**NRC Concerns Relating to
Steam Generators at
Indian Point Unit 2**

**Public Meeting with ConEd
July 21, 1998**

Staff Concerns Identified in July 20, 2000 Letter

Figure 8-7
SG 4, U-Bend Tube R2C74, Crack Depth Profiles
Comparison of 800 kHz Pre and Post In Situ Test
NDE Depth vs. Axial Length

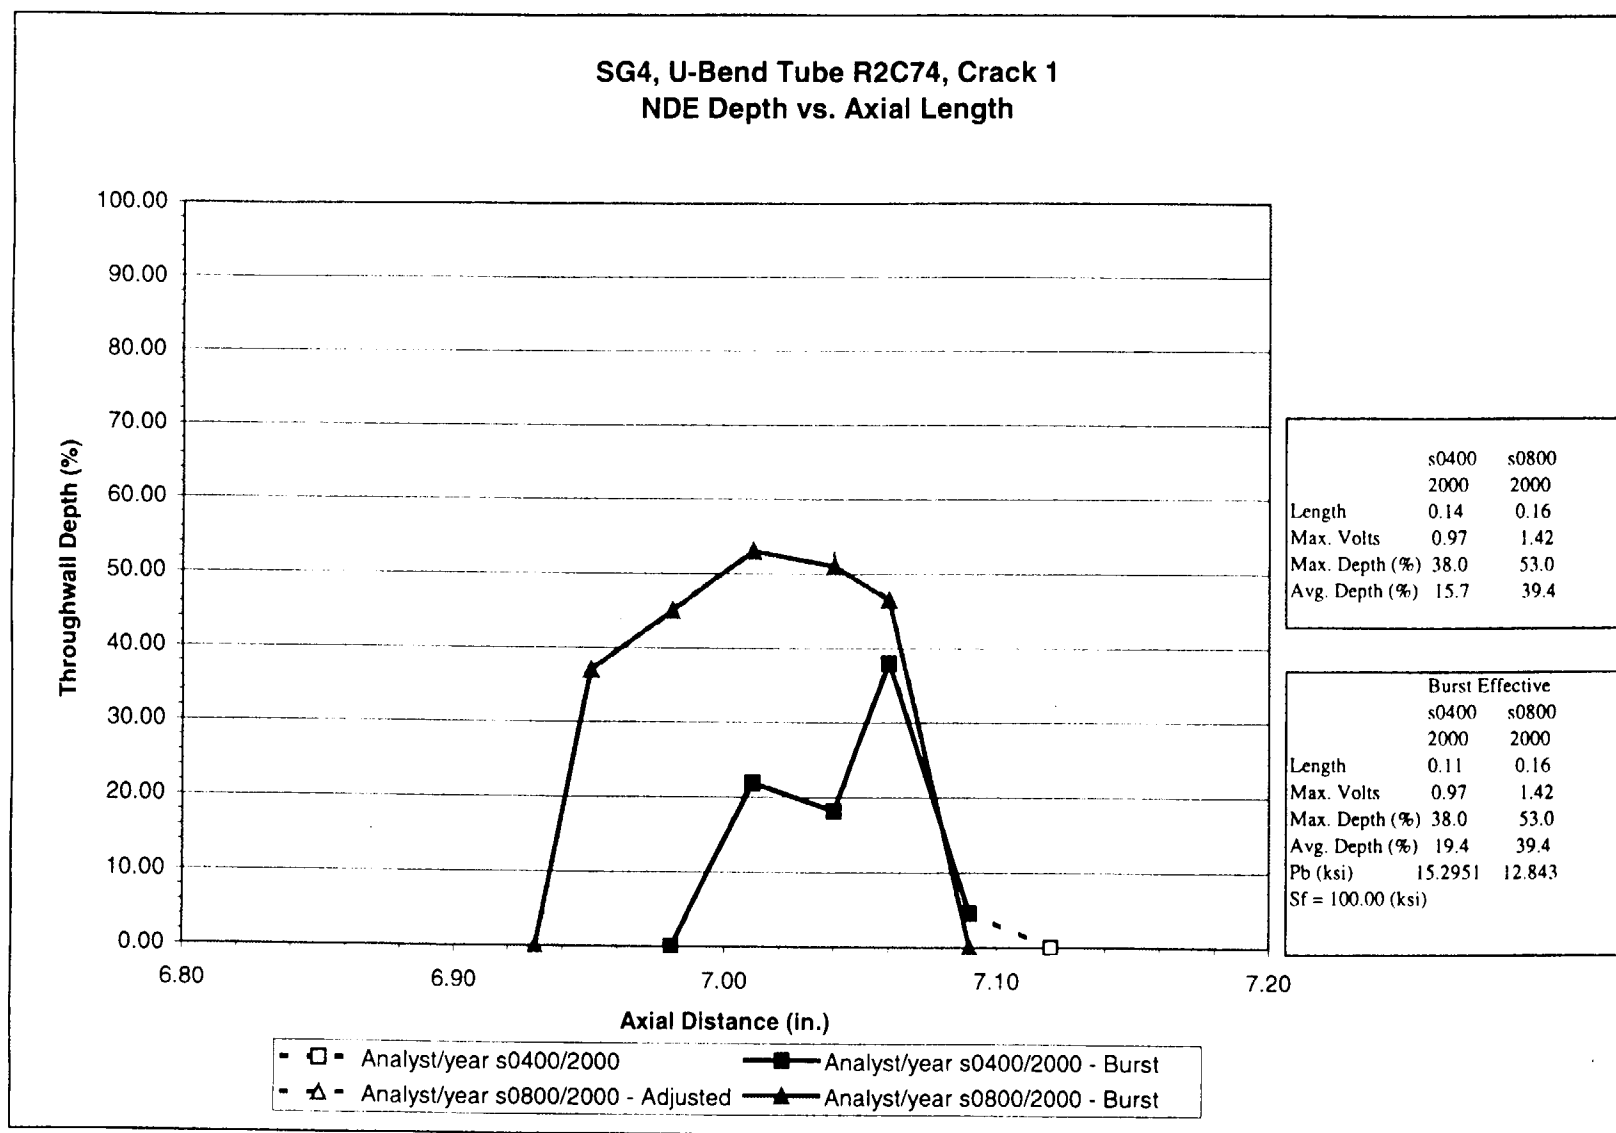
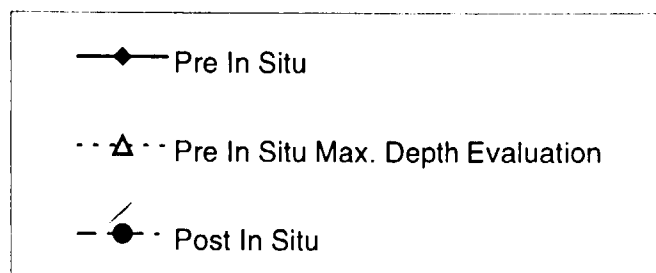
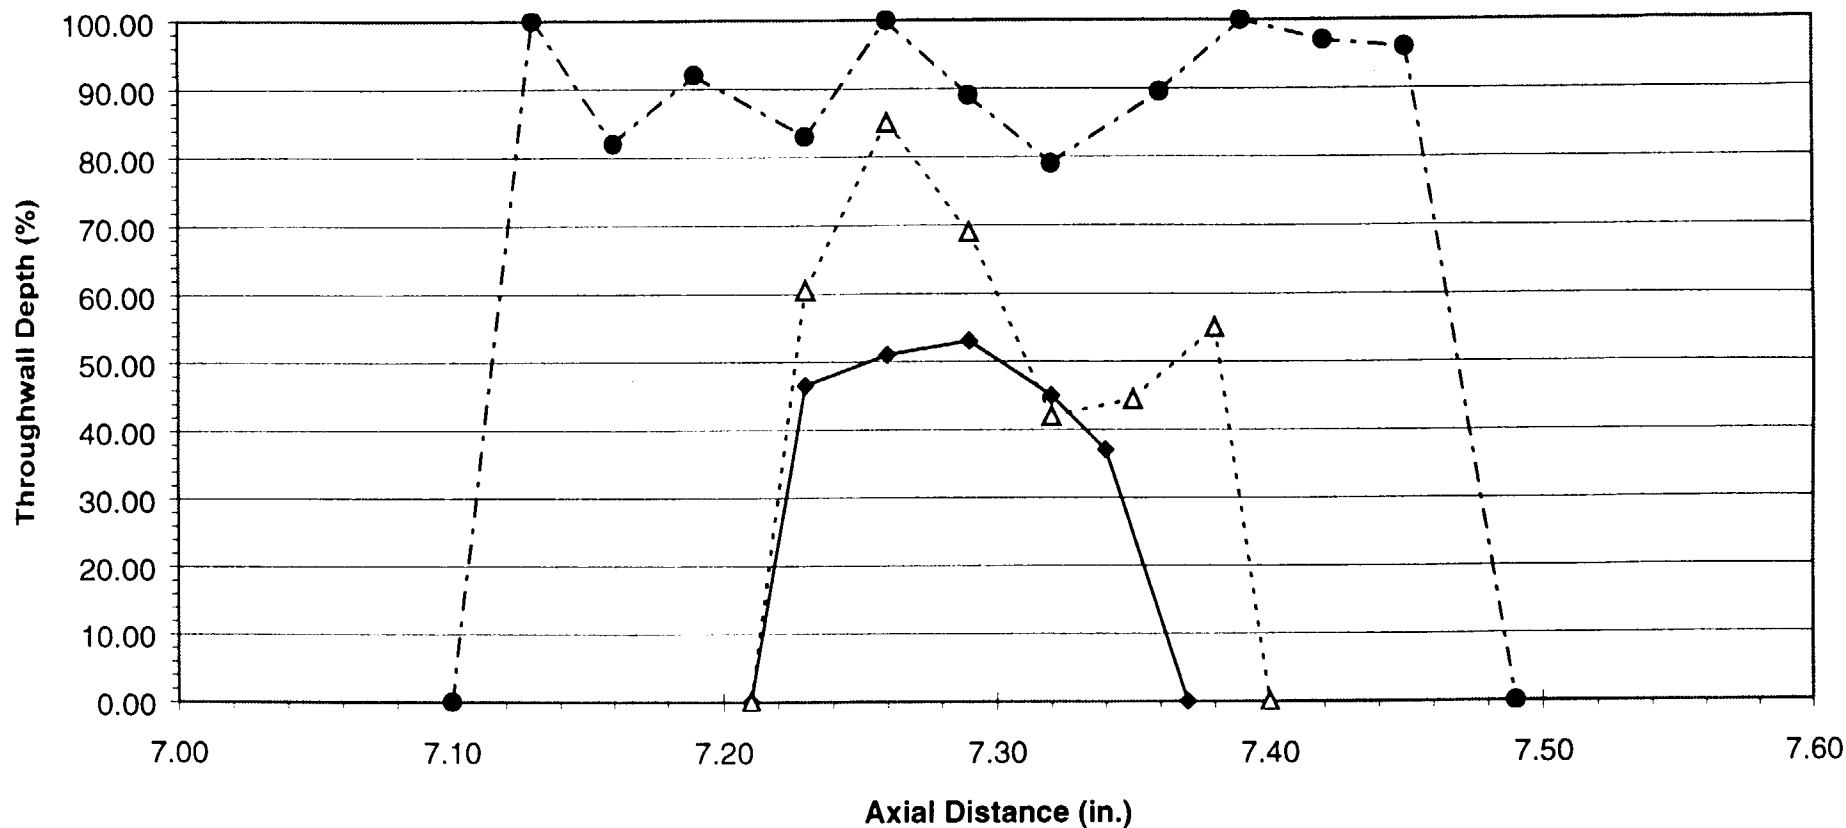
Flaw Size Measurement Error (Cont)

- The above concerns notwithstanding, the staff considers flaw sizing measurements based on the high frequency probe 800 KHz data to be more accurate than those based on the mid-range probe 400 KHz data due to significantly improved signal to noise.
 - Burst pressure estimates based on the 800 KHz flaw size measurements are 18% lower than those based on the 400 KHz measurements. Licensee needs to explain why its analysis appears insensitive to which set of measurements is used.
- The staff believes the results of the licensee's analyses are very sensitive to the assumed measurement error distribution. These distributions are used to estimate the number and size of flaws which may remain undetected in tubes which are still in service.
